A303 Amesbury to Berwick Down

Proposed Changes Consultation Booklet

July 2019

Proposed Changes Consultation Booklet – Correction Sheet

Figure 3-1 Extract from De-Trunking Plans [APP-015]

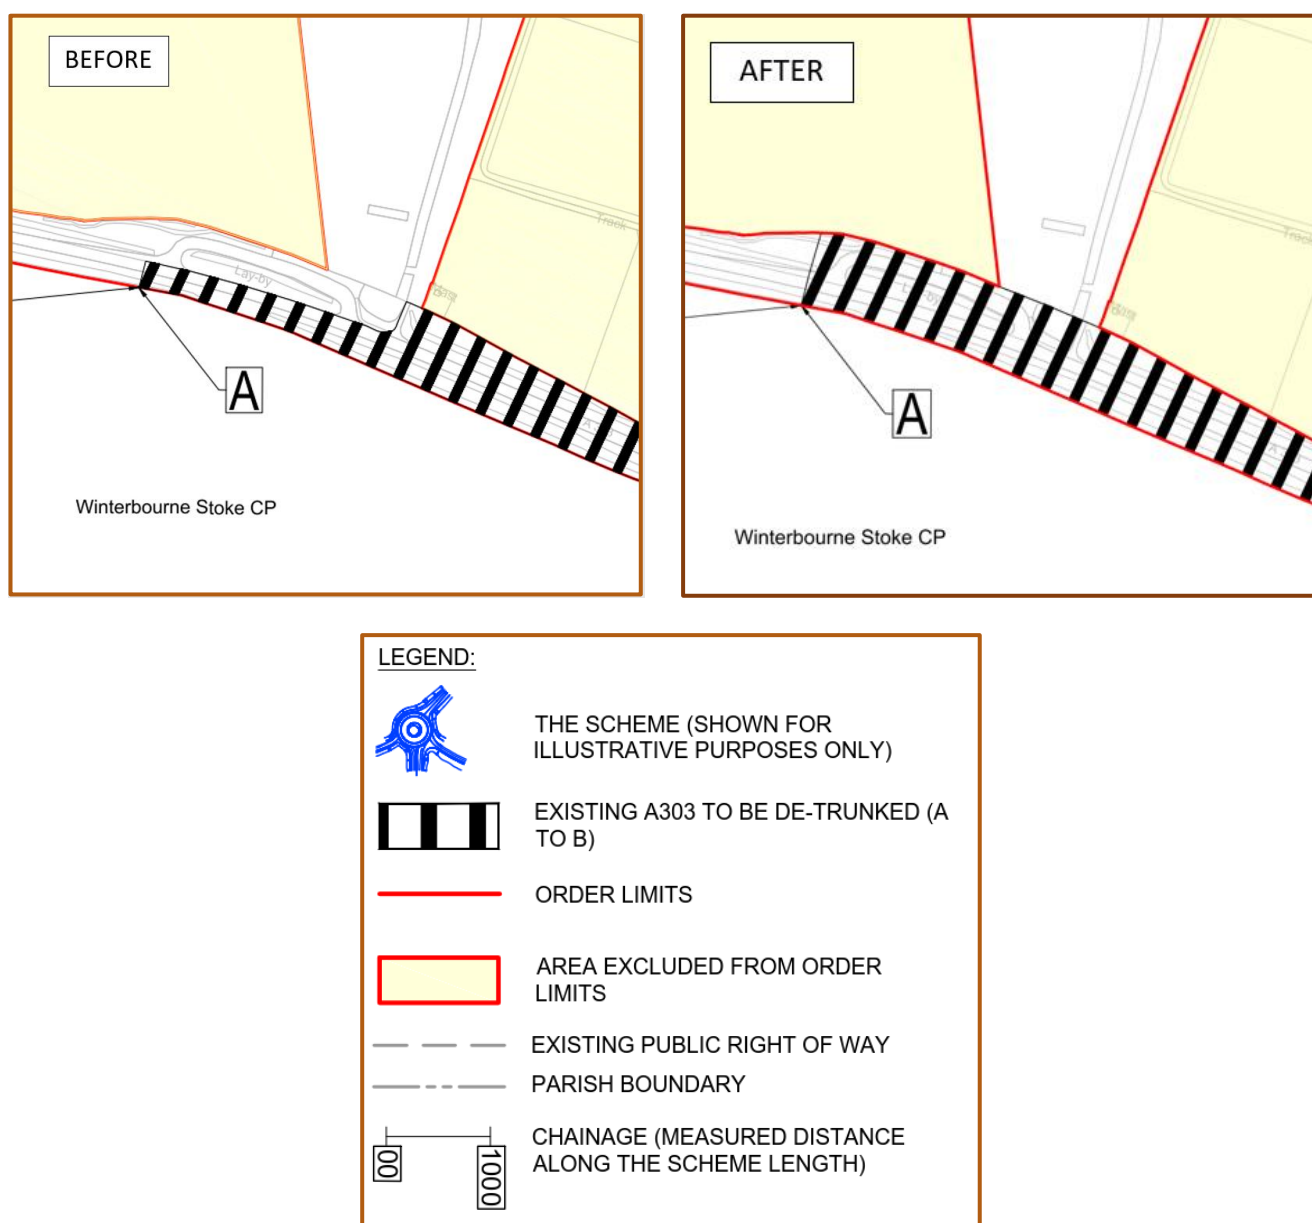
- 4.2.1 The proposed change involves the existing lay-by being de-trunked. As a consequence of this, responsibility for the lay-by would be transferred from Highways England to Wiltshire Council. The lay-by would be transformed into a sloping grassed verge and would no longer be accessible to vehicles.
- 4.2.2 The proposed change involves amendments to the De-Trunking Plans (Sheet 1 of 3) [APP-015], extending the area of proposed de-trunking on this length of the existing A303 to include the lay-by. This would require zebra hatching to be added in the plan to the lay-by to show the proposed de-trunking, as shown in Figure 3-1 below.

Figure 5-1 Extract from De-Trunking Plans [APP-015]

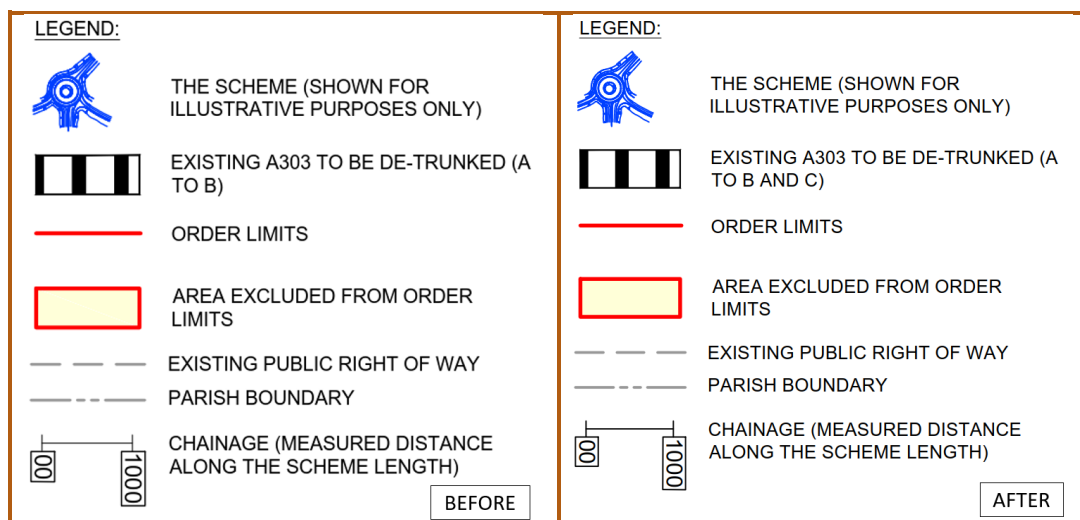
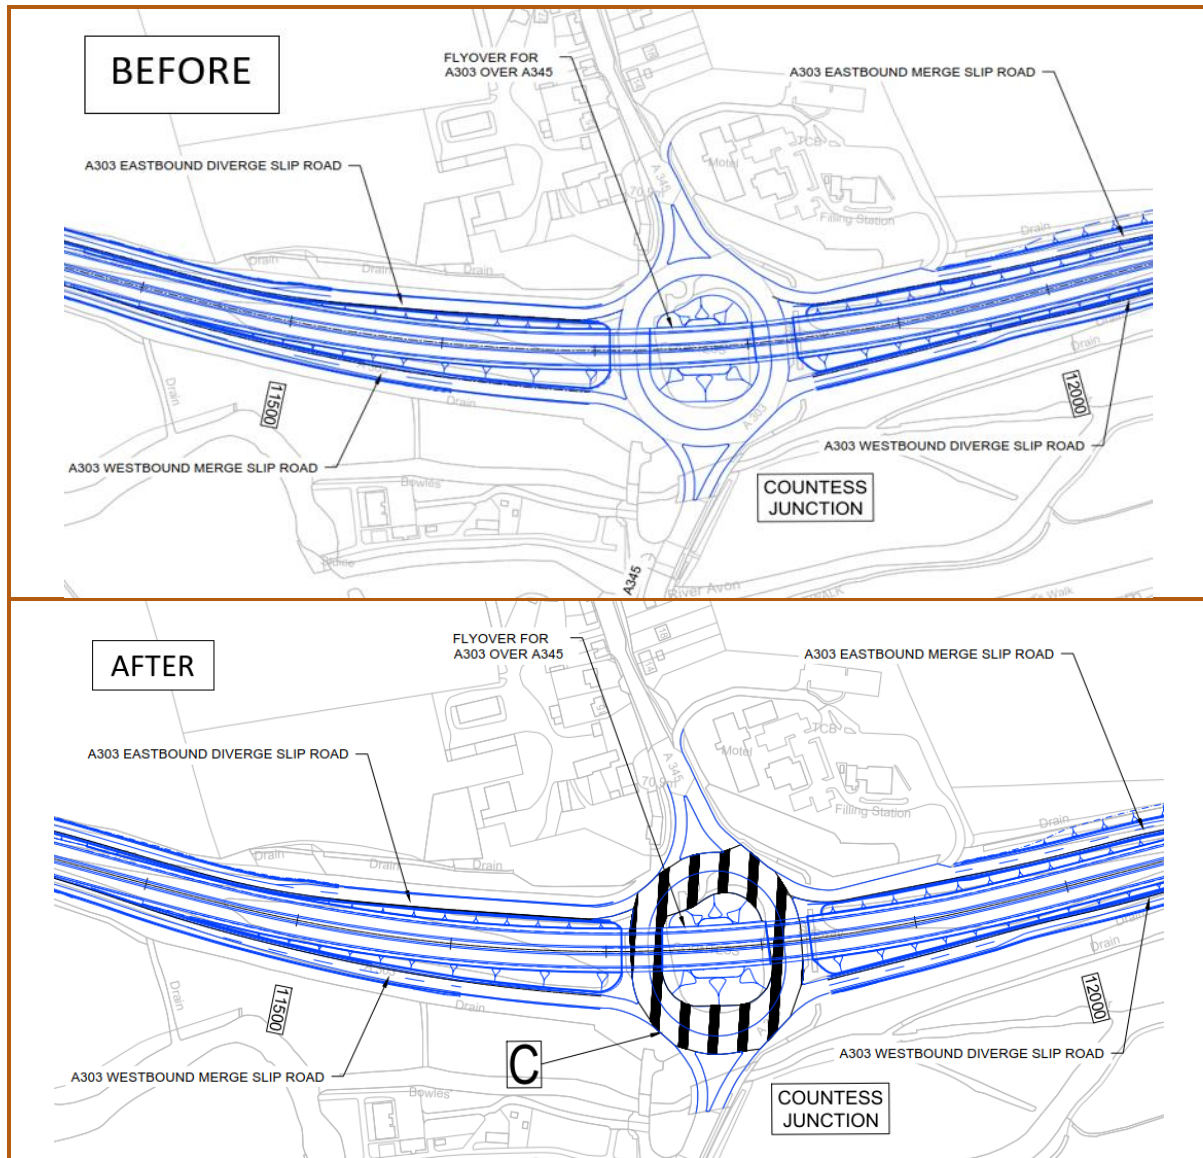
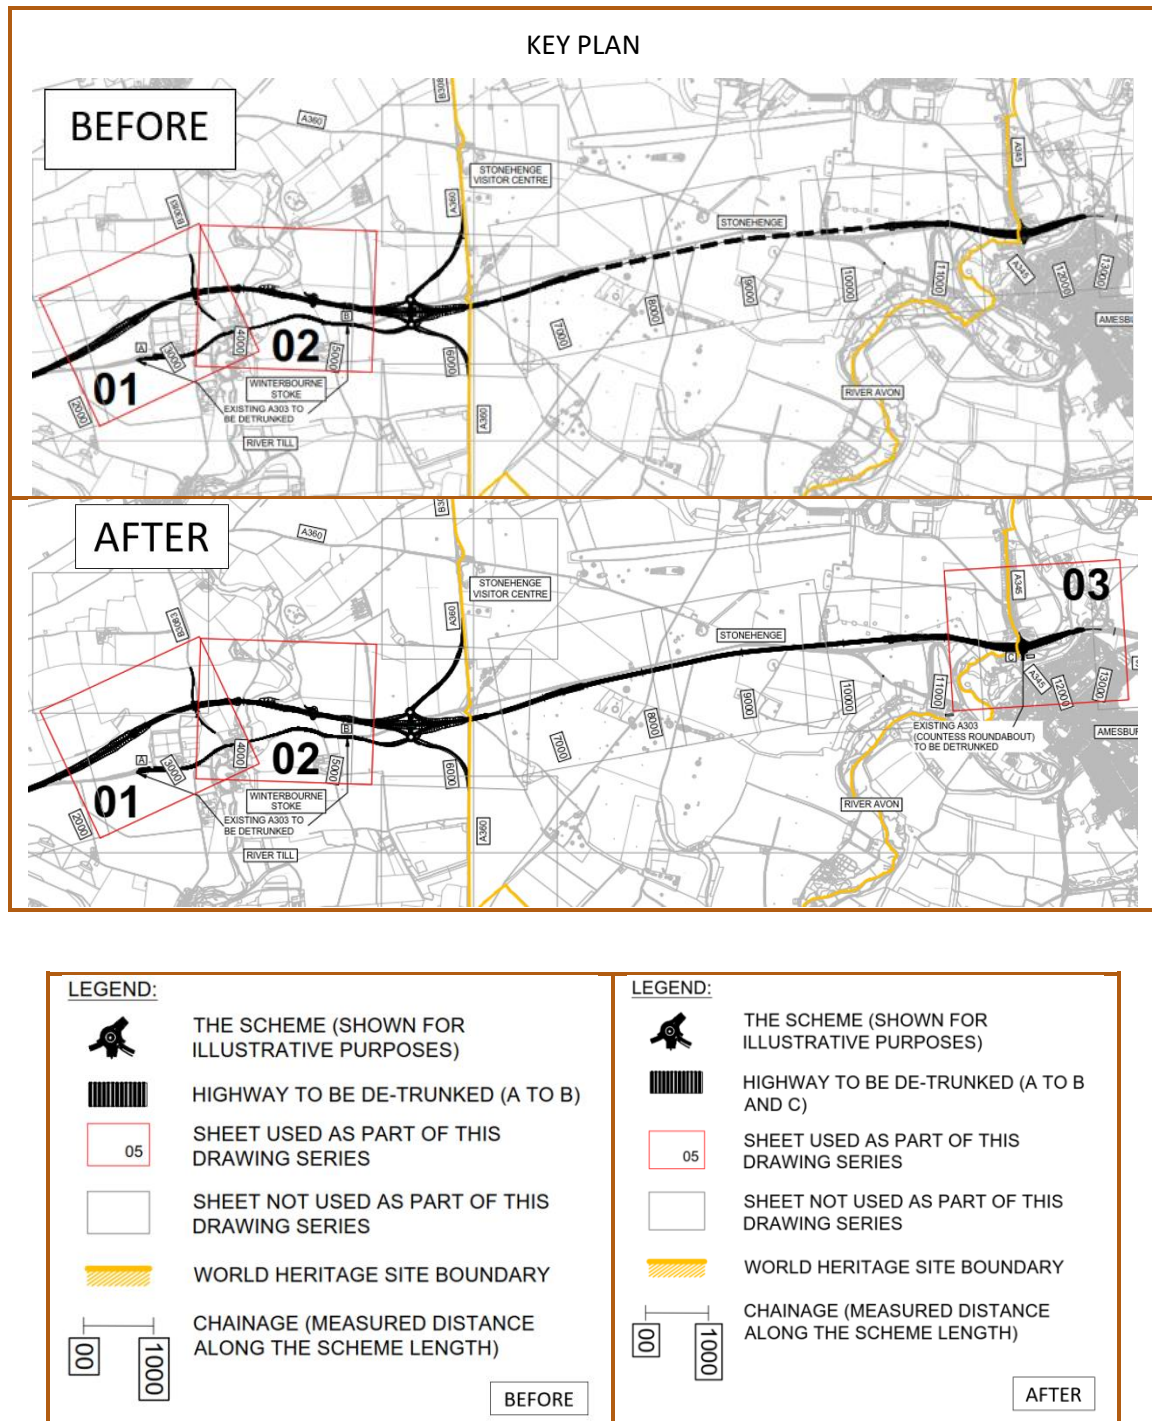
- 5.2.1 The proposed change involves the circulatory carriageway at Countess Roundabout being re-categorised as a local (non-trunk) road and responsibility for it being transferred from Highways England to Wiltshire Council. The roundabout would be classified as the A345 (rather than the A303) for consistency with the main roads running to the north and south of the roundabout. This is an administrative change only and there would be no change to the road surface or to the way the carriageway is used.

- 5.2.2 To give effect to the proposed change, Highways England would need to amend the De-Trunking Plans [APP-015] which would see zebra hatching added to the circulatory carriageway of Countess Roundabout, as shown in Figure 5-1 below. In addition, minor amendments to Part 9 of Schedule 9 to the draft Development Consent Order, to designate the de-trunked circulatory carriageway at Countess Roundabout, would be required.

- 5.2.3 An additional sheet to the set of De-Trunking Plans is required to cover the de-trunked circulatory carriageway at Countess Roundabout. As a consequence, the proposed change will also result in the amendment of the De-Trunking Plans Key Plan.

Figure 6-1 Extract from the Classification of Roads Plan [APP-016]

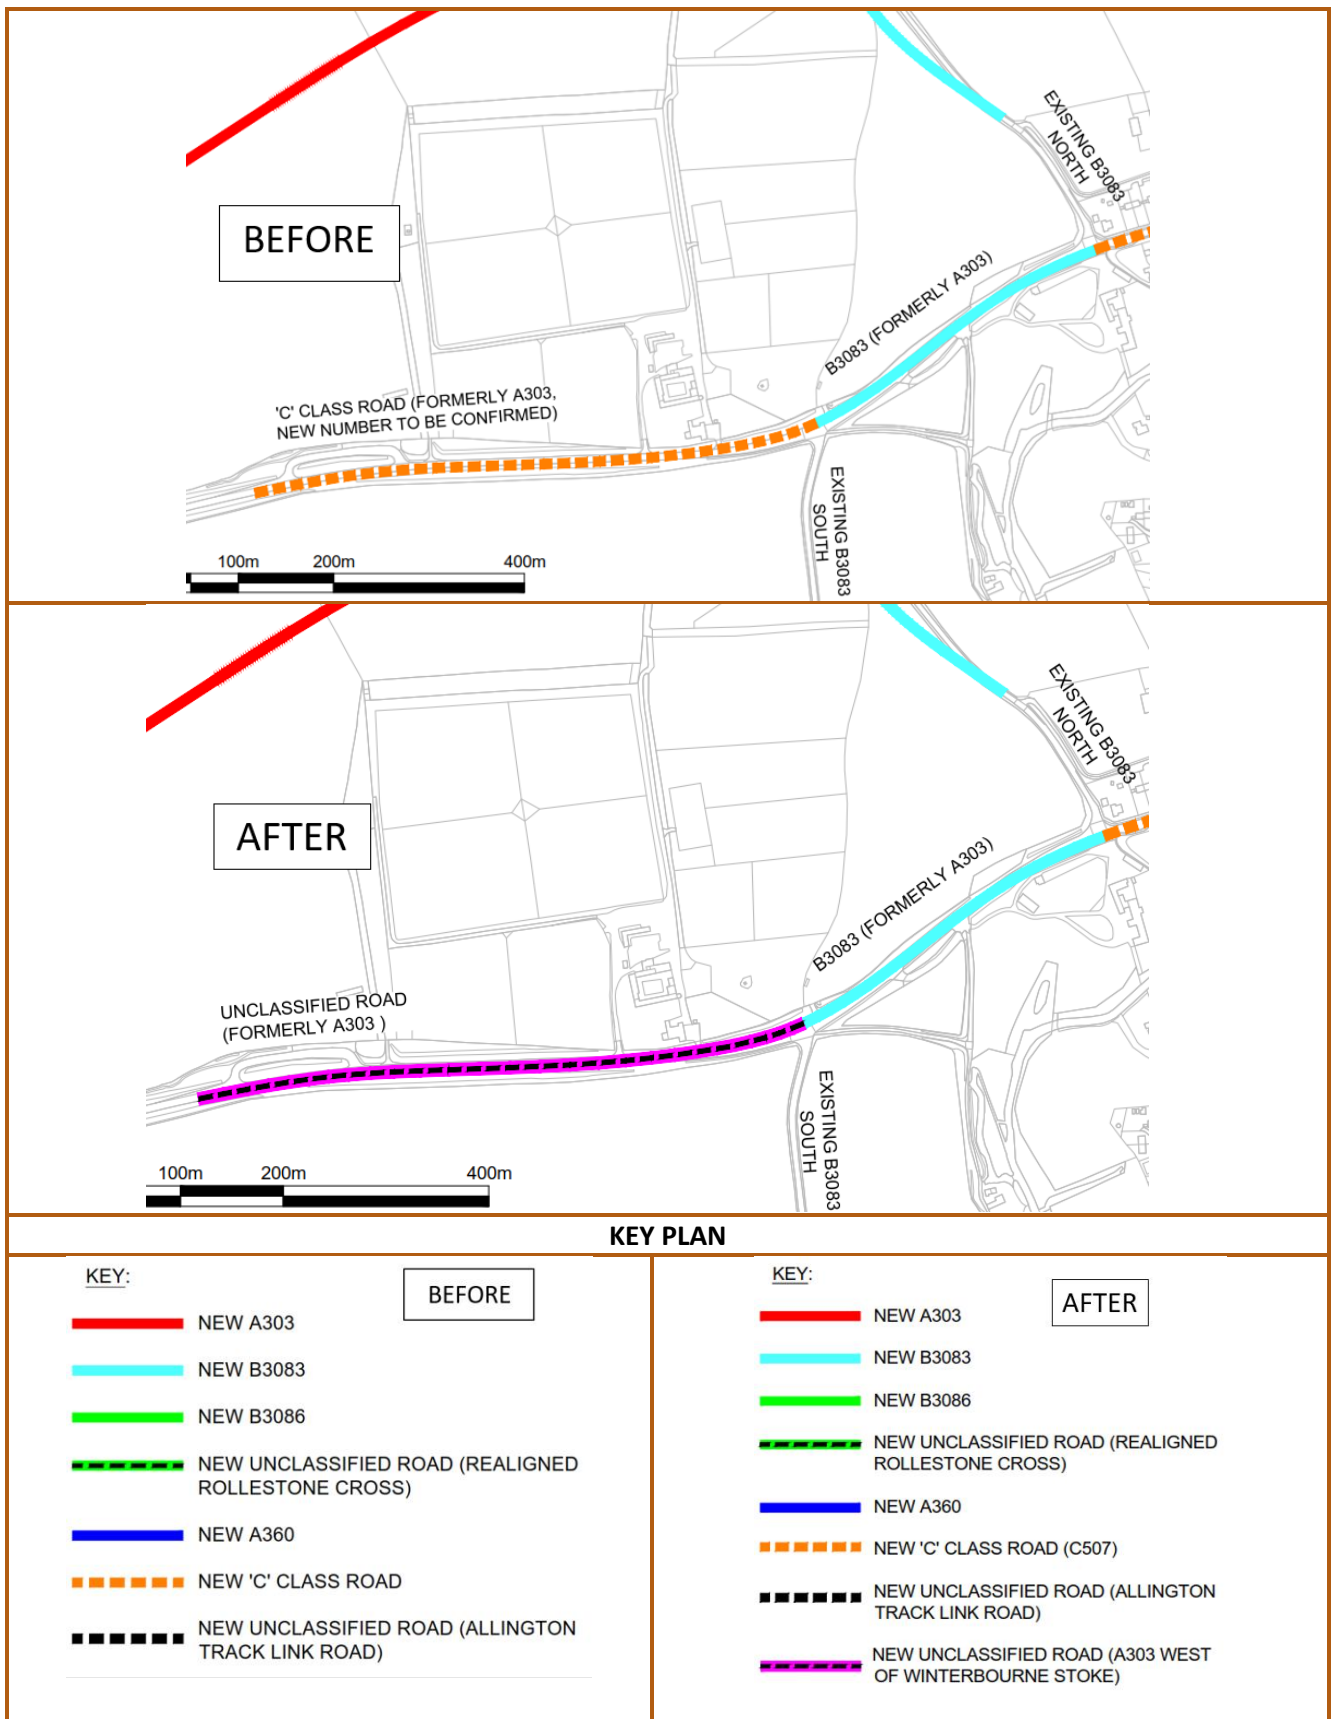
- 6.2.1 The proposal is for the existing A303 between Winterbourne Stoke and Berwick Down to be declassified, changing from its current trunk road status to an unclassified road (a 'D road'), rather than to a classified unnumbered road (a 'C road') as was previously proposed in the DCO application.
- 6.2.2 The proposed change requires a change in the Classification of Roads Plan [APP-016] to show the proposed re-classification described above, as shown on Figure 6-1 below. Amendments are also required to the corresponding entries in Part 7 of Schedule 9 to the draft Development Consent Order – [REP4-018].
- 6.2.3 This proposed change would not require any land currently outside the Order limits or any additional land as defined in the Infrastructure Planning (Compulsory Acquisition) Regulations 2010 ('CA Regulations'); and the CA Regulations would therefore not be engaged.

Figure 7-1 Extract from General Arrangement Drawings [APP-012]

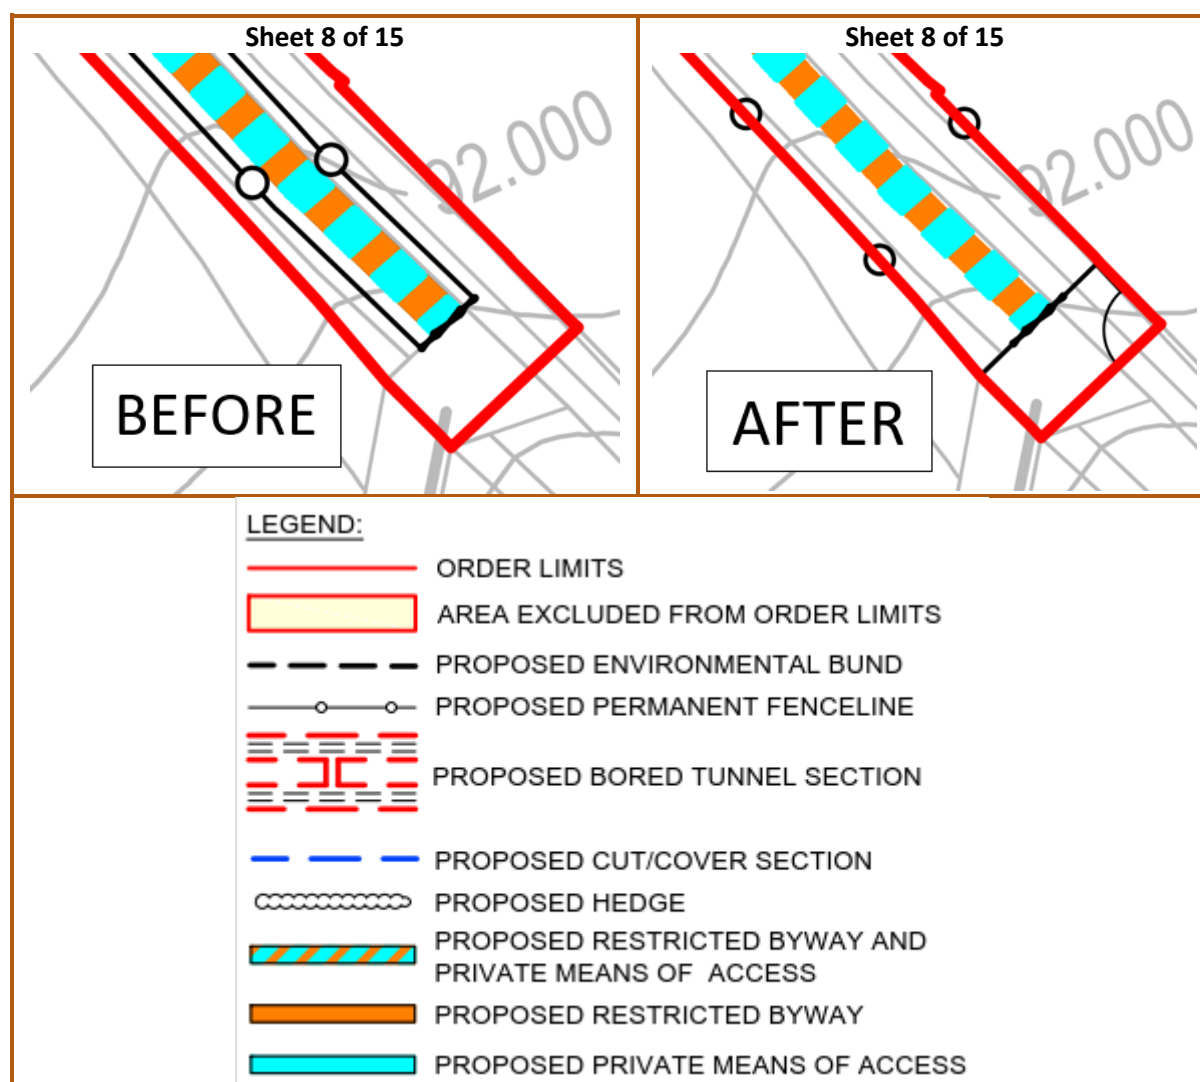
- 7.2.1 The proposed change involves the provision of a space to allow vehicles to turn immediately south east of the point where it is proposed that the existing Stonehenge Road is converted to a new restricted byway.

- 7.2.2 As noted above, the new turning head would be located at the easternmost end of the proposed restricted byway (with private means of access) along the route of part of Stonehenge Road. The General Arrangement Drawings (Sheet 8 of 15) [APP-012] would need to be updated to show the proposed turning head. Its location is shown on the 'before' and 'after' extracts from the General Arrangement Drawings in Figure 7-1 below, where the 'before' extract shows the Scheme detail as originally applied for, with no provision for a turning head on Stonehenge Road.

- 7.2.3 The 'after' extract shows how the Scheme would look if this proposed change was accepted into the examination of the Application by the Examining Authority: the turning head would extend southwards for a distance of approximately 10 metres and would occupy an additional verge area on the east side of Stonehenge Road of approximately 37.6 square metres.
